Title: ERID-111328 SUBMITTAL OF THE RESPONSE TO THE NOTICE OF DISAPPROVAL FOR THE INVESTIGATION WORK PLAN FOR LOWER PAJARITO CANYON AGGREGATE AREA AND REVISION 1, INCLUDING 2 CD'S, EP2010-0521, EP2010-0522, LA-UR-10-7635

To:(Addressees - Organization) JAMES BEARZI, NMED

From:(Senders - Organization) MICHAEL J GRAHAM, LANL
 GEORGE J RAE, DOE

Figure 4.1-3 Proposed sampling locations for SWMU 18-001(a)

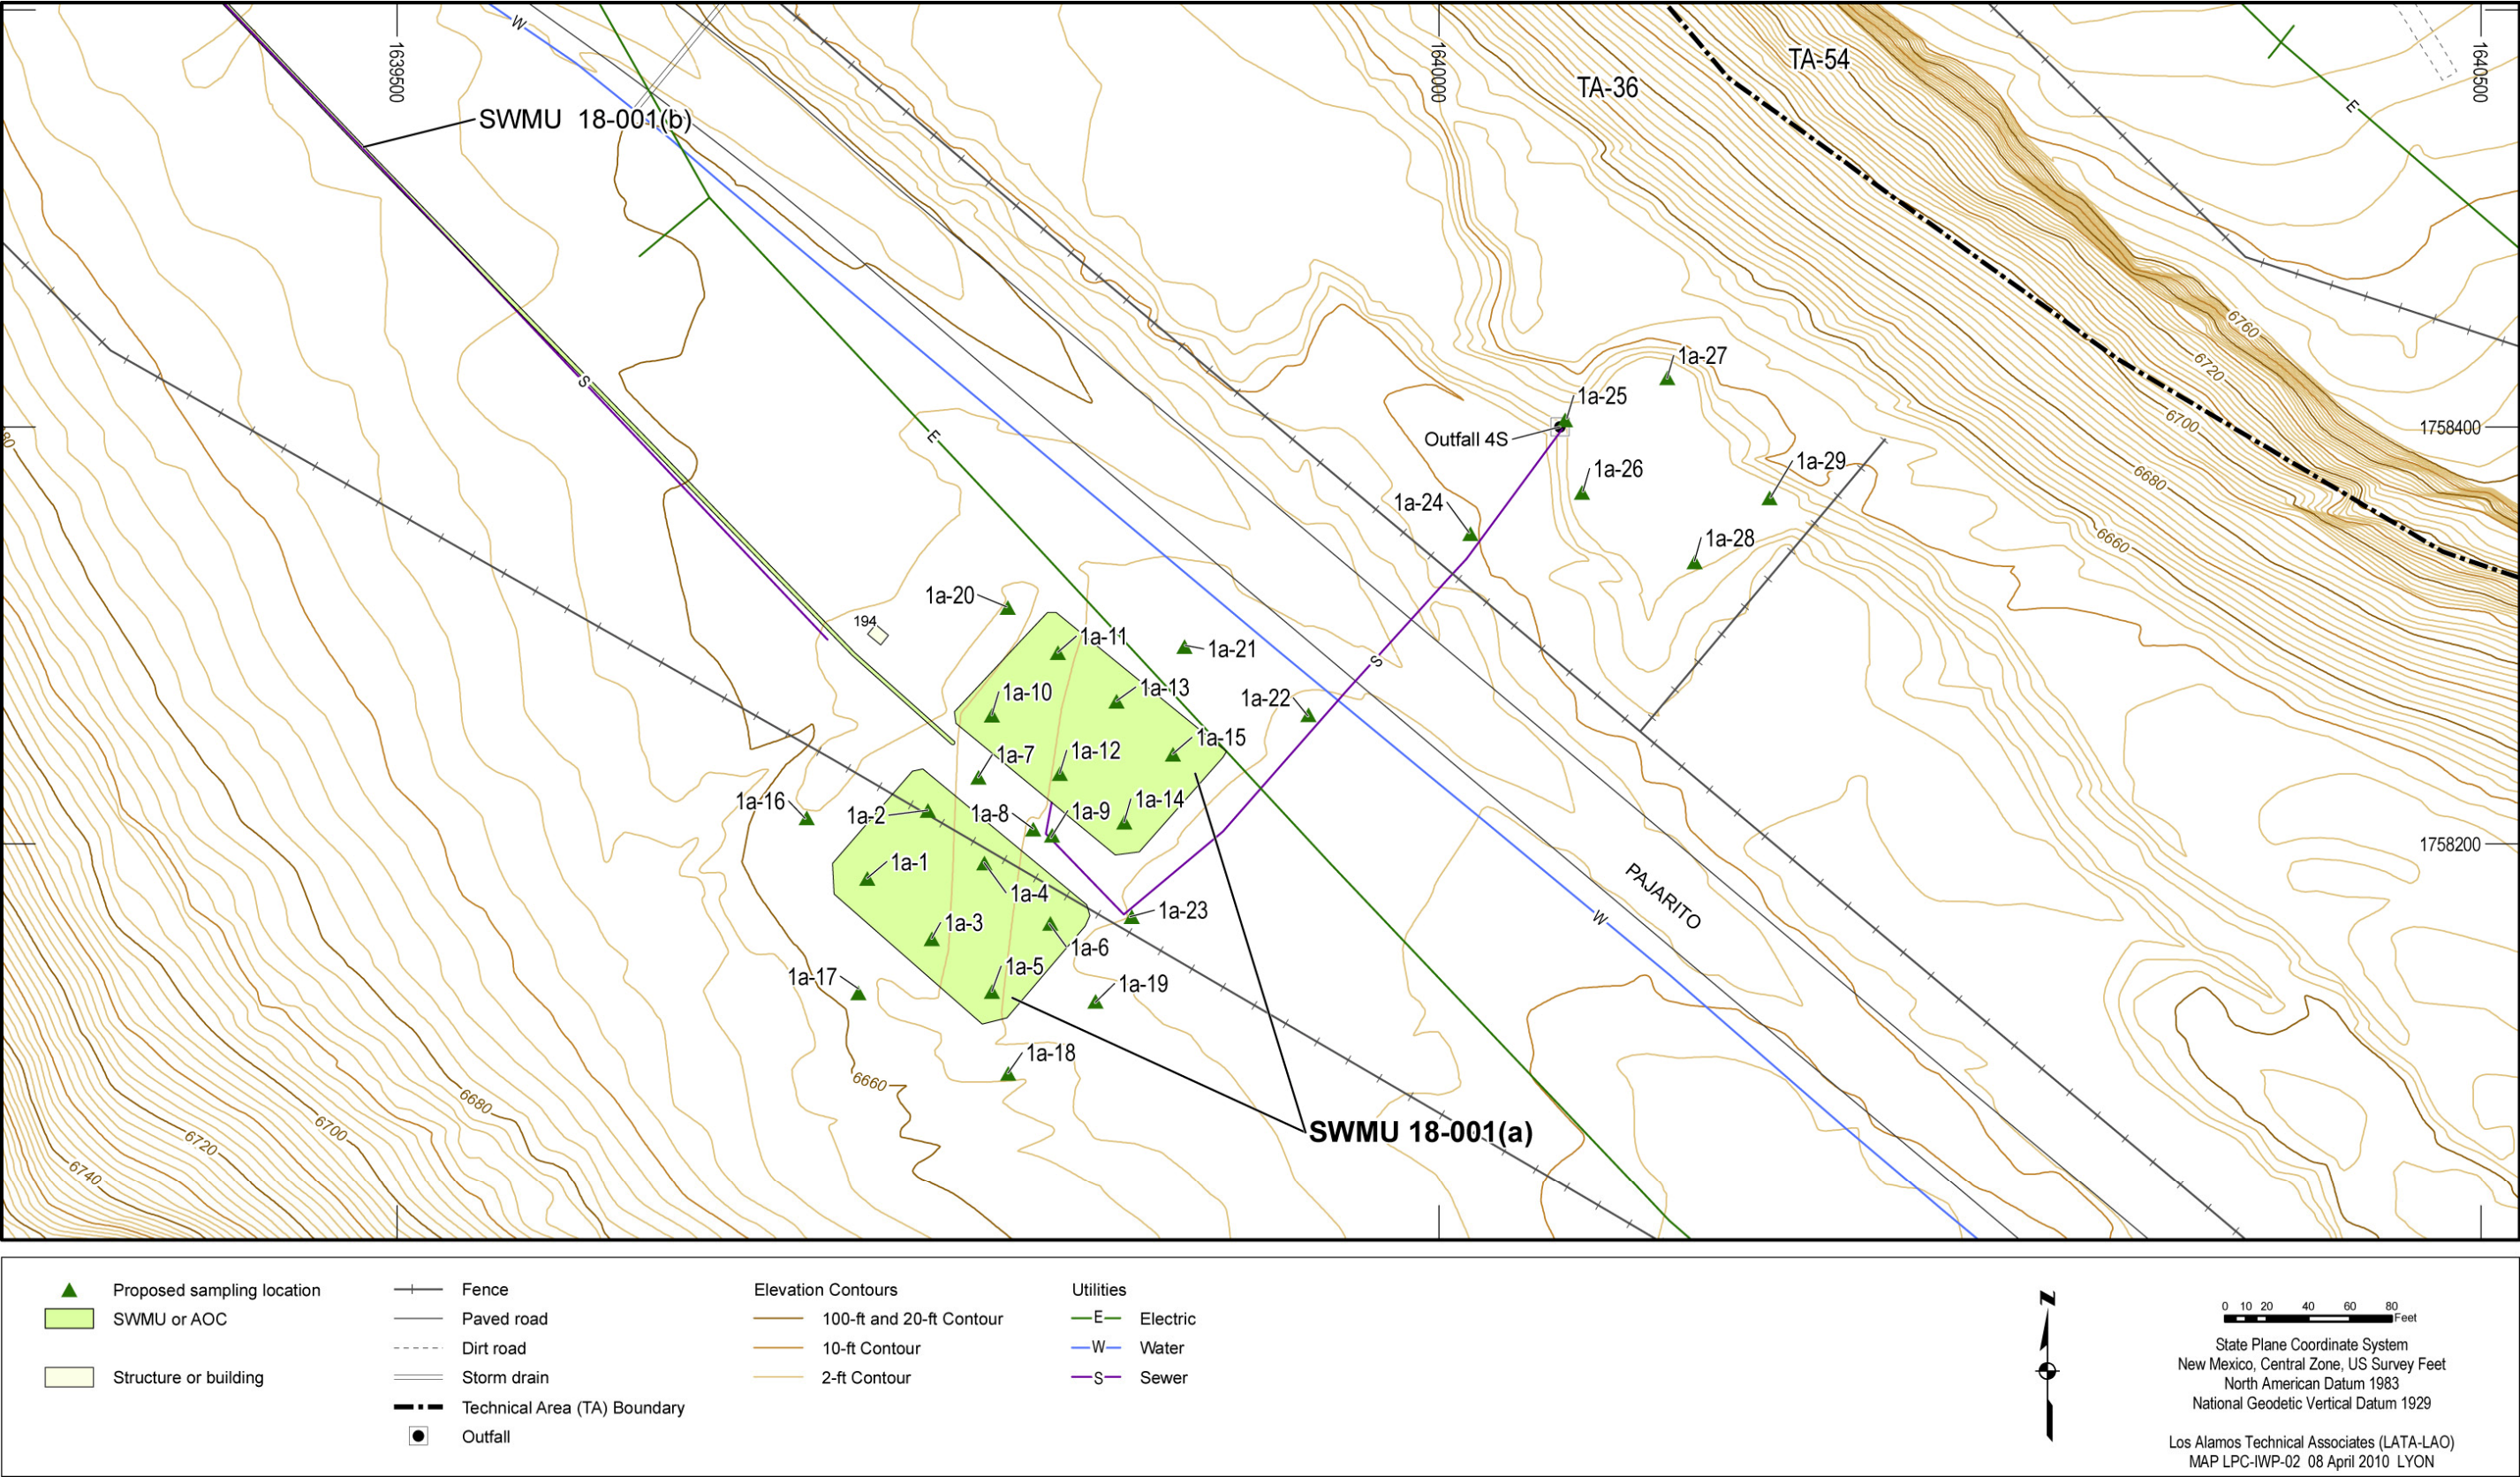
Permittees' Statement: "Eight surface and subsurface samples will be collected from location 1a-20 (Figure 4.1-3). Samples will be collected from eight depths (0–1 ft, 14–15 ft, 29–30 ft, 50–51 ft [below ground surface] bgs, and at 25-ft intervals thereafter to a depth of up to 150 ft bgs). Additional sampling intervals may be added to this location to ensure that a sample is collected from every geologic unit encountered."

5. **Section 4.1.1.3, Scope of Activities for SWMU 18-001(a), pages 13 and 14 and Figure 4.1-3, Proposed sampling locations for SWMU 18-001(a), page 69:**
